City of Pembroke Pines
Planning & Economic Development Department
601 City Center Way 3rd Floor
Pembroke Pines FL, 33025

Agenda Date:	June 26, 2025	Application ID:	SP2024-0009
Project:	AT&T Wall and Egress	Project Number:	PRJ2024-0012
Project Planner	Cole Williams, Senior Planner		
Owner:	Southern Bell Telephone & Telegraph Company	Agent:	Lisset Morejon
Location:	13900 Pines Boulevard	Commission District	4
Existing Zoning:	A (Agriculture)	Existing Land Use:	Office Park
Reference Applications:	ZC2001-04, SP 98-75, SP 95-17, SUB 90-08, SP 82-05		
Applicant Request:	Addition of a egress point and wall along the southern property line.		
Staff Recommendation:	Approval		
Final:	<input checked="" type="checkbox"/> Planning & Zoning Board <input type="checkbox"/> City Commission		
Reviewed for the Agenda:	Director:  Assistant Director:

Lisset Morejon, agent, is requesting approval of a wall and new egress point with associated driveway along the southern property line at the AT&T site located at 13900 Pines Boulevard.

FIRE HYDRANT DETAIL

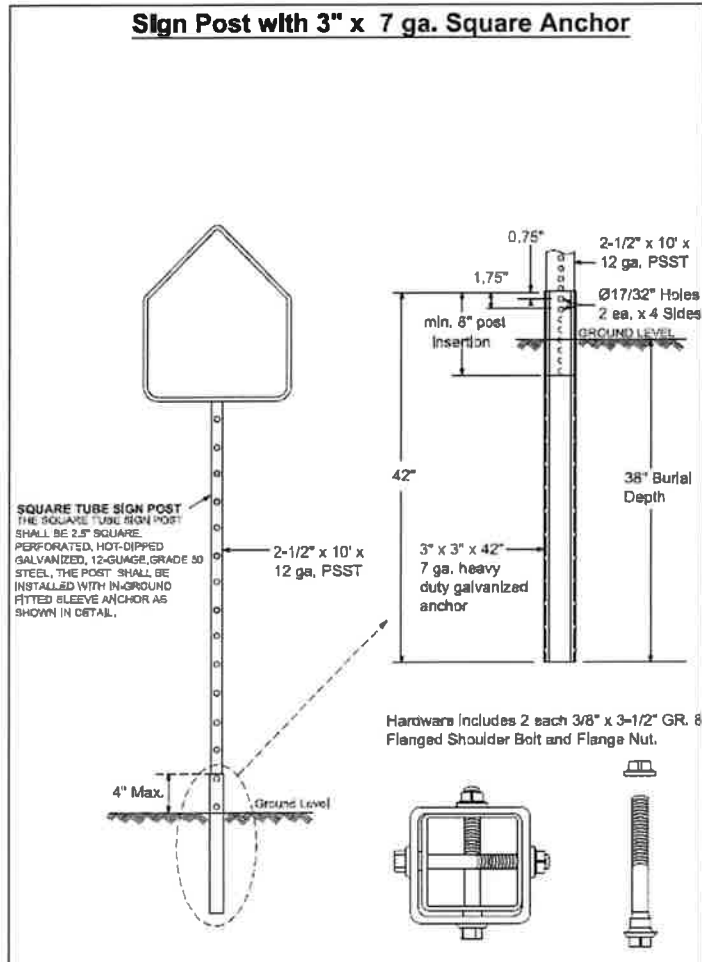
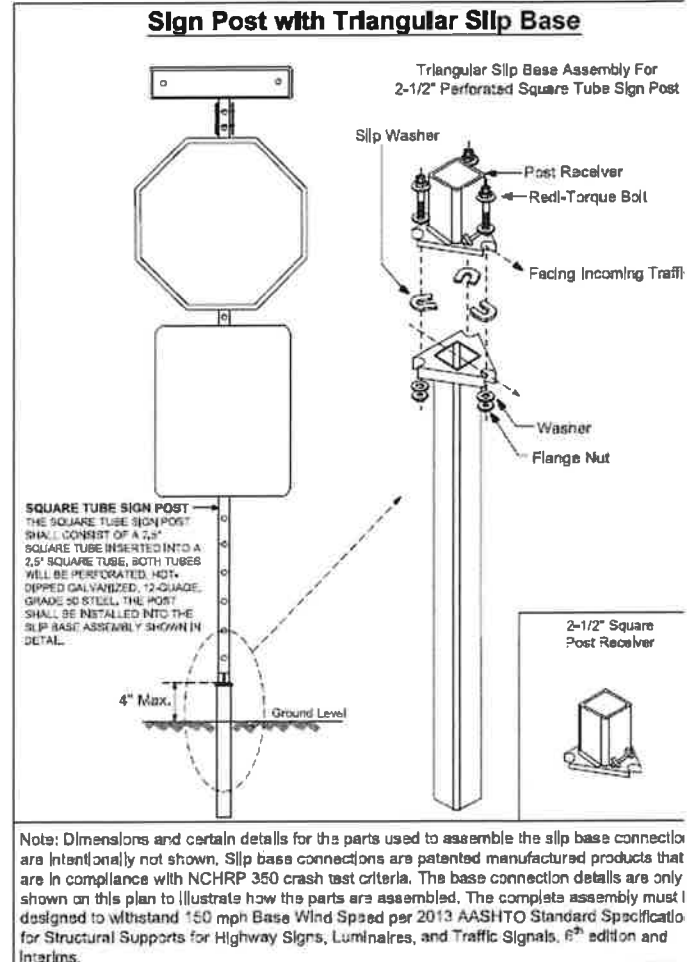
NOTE: Fire Hydrant Detail to be provided on submittal.

11. Place note on plan: All Support/Sign Posts Shall Conform To Current Broward County Traffic Engineering Division (BCTED) Standards For Square Tube Sign Posts With Either A Square Anchor Or Triangular Slip Base per BCTED ‘Ground Sign Assembly Details’.

Ground Sign Assembly Details

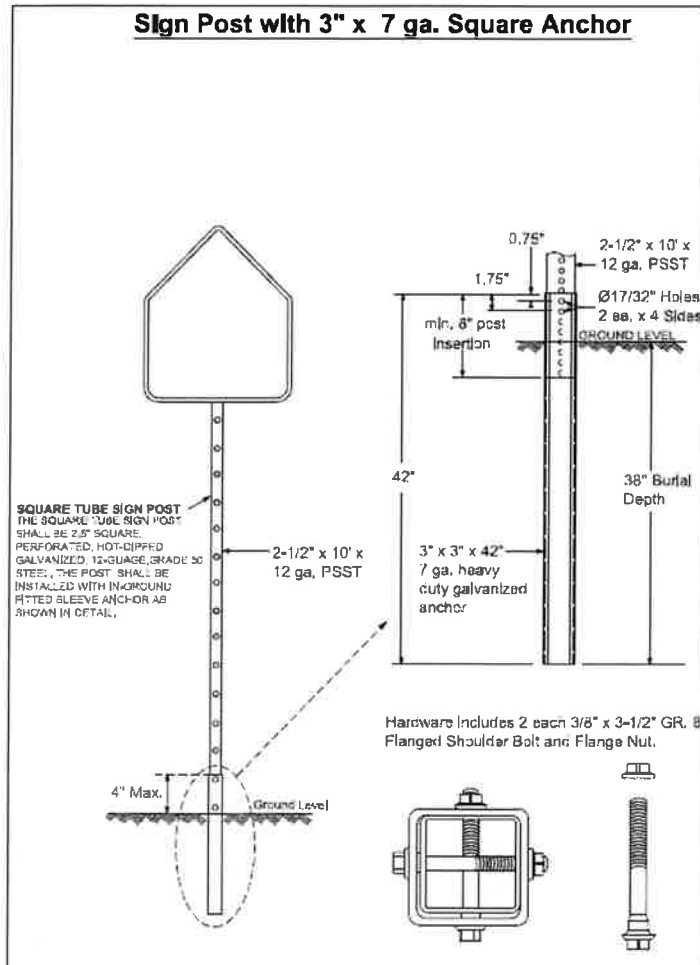
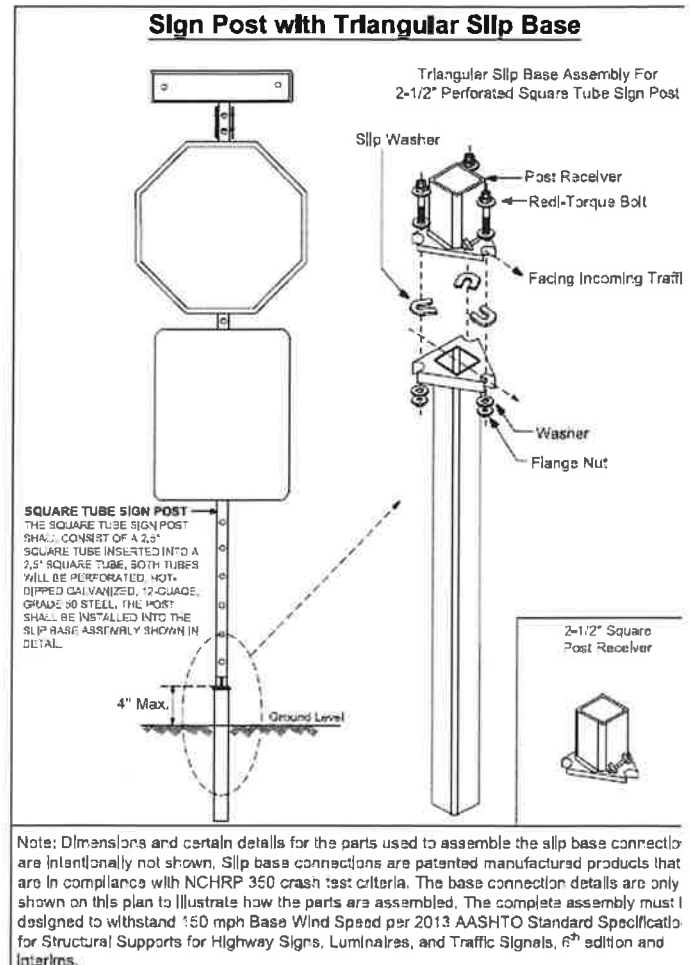
11. Place note on plan: All Support/Sign Posts Shall Conform To Current Broward County Traffic Engineering Division (BCTED) Standards For Square Tube Sign Posts With Either A Square Anchor Or Triangular Slip Base per BCTED 'Ground Sign Assembly Details'.
